RESOLUTION

R72 – 2018

**Certificates of Appropriateness for work in the Historic Districts:
1036 W. Tuner Street, 618 N. 6th Street, 429 N. 8th Street, 1031 Linden Street**

**CITY OF ALLENTOWN
HISTORIC ARCHITECTURAL REVIEW BOARD
FINAL REVIEW SHEET
May 7, 2018**

Property located at: 618 N 6th Street

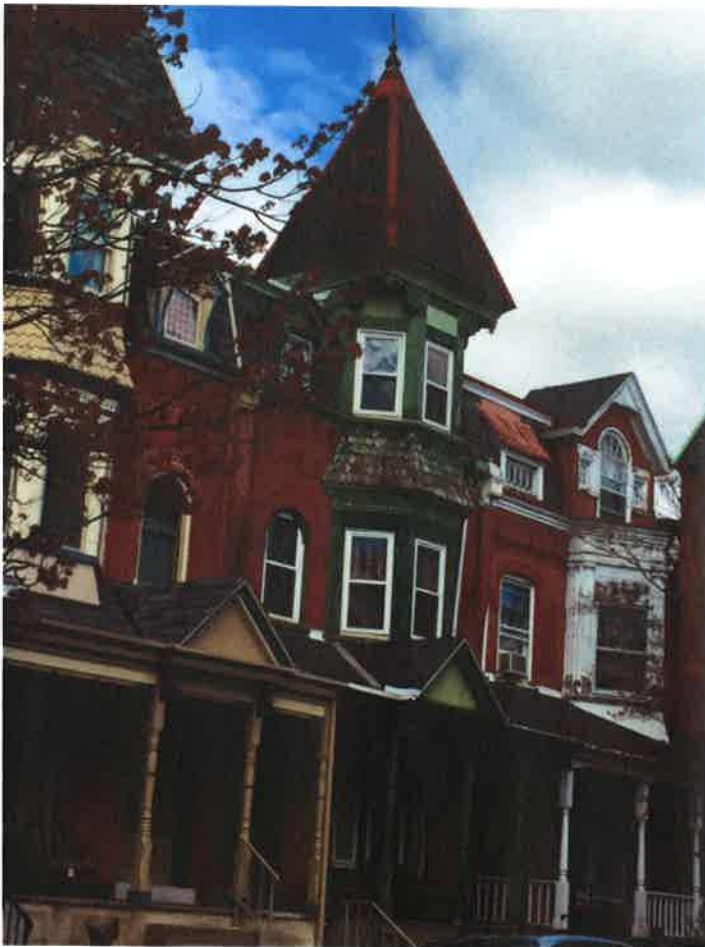
Evaluation, effect on historic district, recommendations: The proposed restoration work is historically appropriate with some notes on direction:

- As much funding as possible should be directed towards window restoration and replacement where needed (especially the arched window). New windows should be wood, aluminum-clad wood, or appropriate fiberglass or composite per Design Guidelines. Any original wood windows should be scraped and painted. New storm windows should be considered for energy efficiency where needed but a color other than white recommended.

- Wood balustrades would be appropriate for the porch, and may be necessary for code/safety. Heavy square balusters might be historically appropriate if at least 2" square, although turned would be more historically appropriate.

- Specification for porch light should be submitted for staff approval if replaced.
- Slate and cedar shingle replacements, as well as any re-pointing, should be done carefully to blend appropriately with existing. Brickwork appears to be in good condition, and with such a fine mortar line, re-pointing should be limited and must follow Preservation Brief #2.

Discussion: The home owner brought pieces of the historic porch ornament that he found on site and proudly showed to the HARB. Reinstallation of these elements was applauded. The HARB said that the replacement of the arched window on the second floor was a high priority and urged the applicants to do this instead of installing a front porch railing. Mr. Lewnes said the other windows on the facade had been replaced and there was not enough money to replace them with more appropriate windows. They would be painted to blend with a new paint scheme to be provided by Ms. Rabinsky. Other discussion focused on miscellaneous details of the proposed work.

1. The proposal to rehab/restore the facade at 618 N 6th Street was presented by Peter Lewnes.
2. Any aluminum capping and siding still existing will be removed.

3. Original porch trim discovered on site will be reinstalled and painted
4. All woodwork, including front porch, will be repaired or replaced in kind, as necessary, and painted

5. Arched window sashes will be reinstalled in the existing arched window on the second floor if budget allows. This is a high priority and should be done if at all possible.

6. Other replacement windows will be painted. If the dormer multi-light window is original it will be retained and painted.
7. A new dusk to dawn porch light (if needed) will be installed after approval by staff.

8. Metal caps and finial on tower roof will be painted, and all slate will be inspected, repaired and replaced with like slate if necessary
9. Any cedar shingles that need replacing will be replaced in-kind and painted.

Property located at: 429 N 8th Street

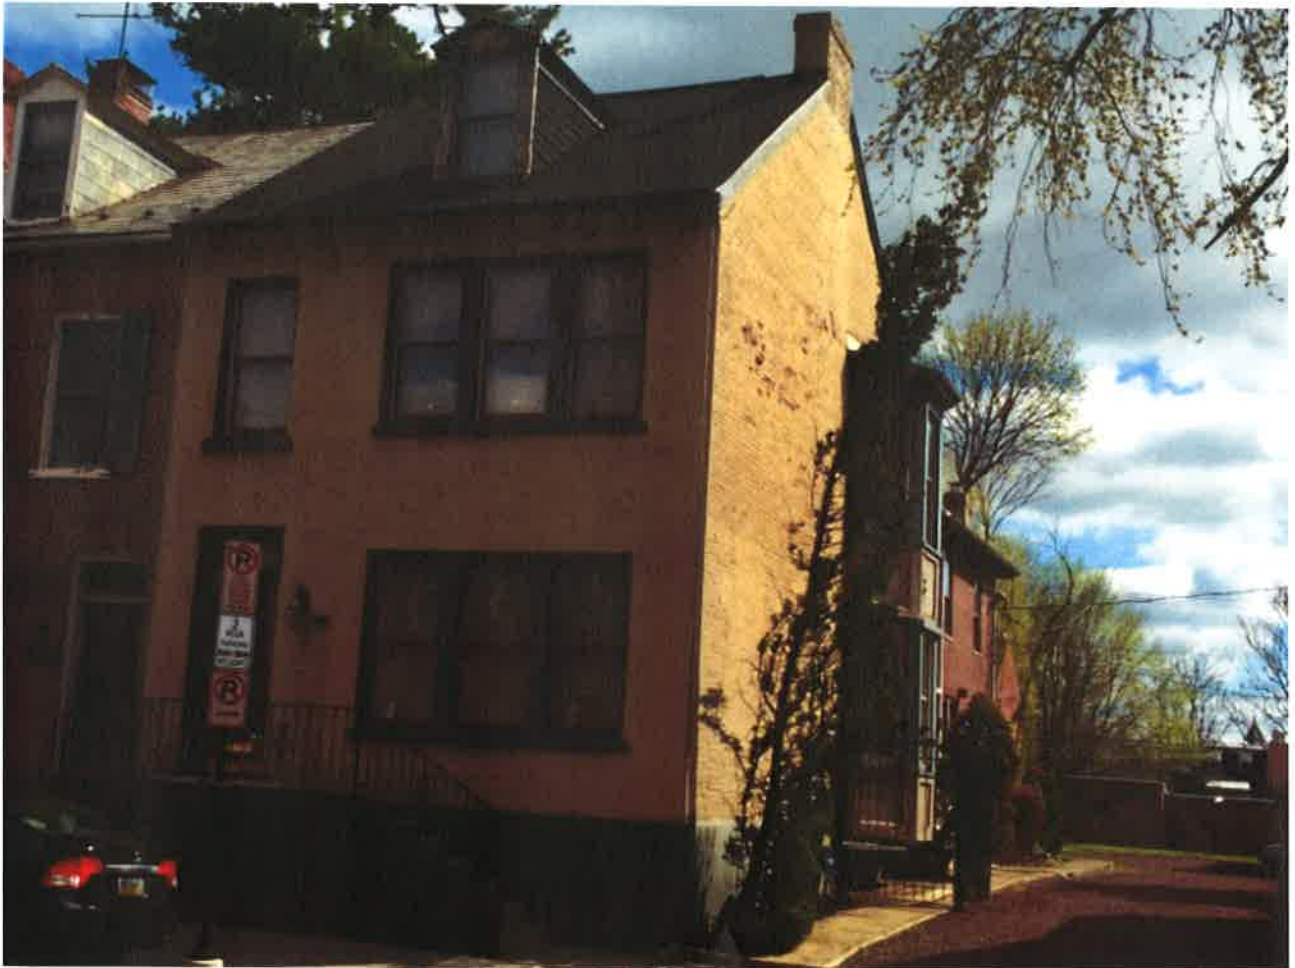
Evaluation, effect on historic district, recommendations: The proposed restoration work is historically appropriate with some notes on direction:

- Removing the existing paint is historically appropriate although the paint may be covering mismatched brick due to the extensive alteration seen on the façade. The area of most concern is around the front door. It appears that a door surround was removed and brick with a different texture is evident there. The reinstallation of an appropriate door surround should be evaluated after the paint is removed. Preservation Briefs should be consulted for removing the paint and repointing. Any grinding out of mortar joints must be carefully done so that the size of the mortar joints is not increased and brick not damaged.

- Replacing the existing non-original windows with appropriate new windows is historically appropriate. Wood, aluminum clad wood, fiberglass, or composite windows, maintaining the 1/1 lite pattern should be used where replacement is necessary. Storm windows could be considered if needed.
- If the downspout needs replacing, it should be round and either in an aged metal finish or painted to match the façade.
- Street numbers on the transom would be appropriate
- If replacing the light, a proposed spec should be submitted for staff approval.

Discussion: The applicant said he would consider installing a door surround if needed after the paint is removed. Mr. Fillman said the water table was probably brownstone. Upon closer inspection of the photo submitted it was concluded that it was stone of some sort. Mr. Lewnes said they would evaluate the removal of paint and do so if possible without damaging the stone. It was clarified that the existing roof was not to be replaced at this time. There was a brief discussion of the windows to be installed after the removal of paint from the brick. Mr. Kimmerly has already given staff approval for appropriate window replacements, but the new windows have not been installed yet.

1. The proposal to renovate the facade at 429 N 8th Street was presented by Peter Lewnes.
2. The existing paint will be removed from the brick on the front and side to just beyond the existing bay windows. Preservation Briefs must be consulted for removing the paint and repointing. Any grinding out of mortar joints must be carefully done so that the size of the mortar joints is not increased and brick not damaged.

3. Repair and repaint brownstone water table and concrete steps. If the brownstone is in good condition the paint will be removed to reveal the natural stone finish.

4. Reinstallation of an appropriate door surround should be evaluated after the paint is removed. Areas around the front door appear to have non-original brick infill.

5. All woodwork on the front and side to just past bay window will be repaired or replaced in kind, and painted.
6. The existing replacement windows will be replaced with HARB approved windows after brick work is completed

7. The historic roof dormer will be restored and painted.
8. Historic iron work will be repainted in flat black
9. Existing downspouts will be replaced if needed and painted to blend with the brick façade.

10. New street numbers will be installed in the transom over the front door.
11. A new dusk to dawn porch light (if needed) will be installed after approval by staff.
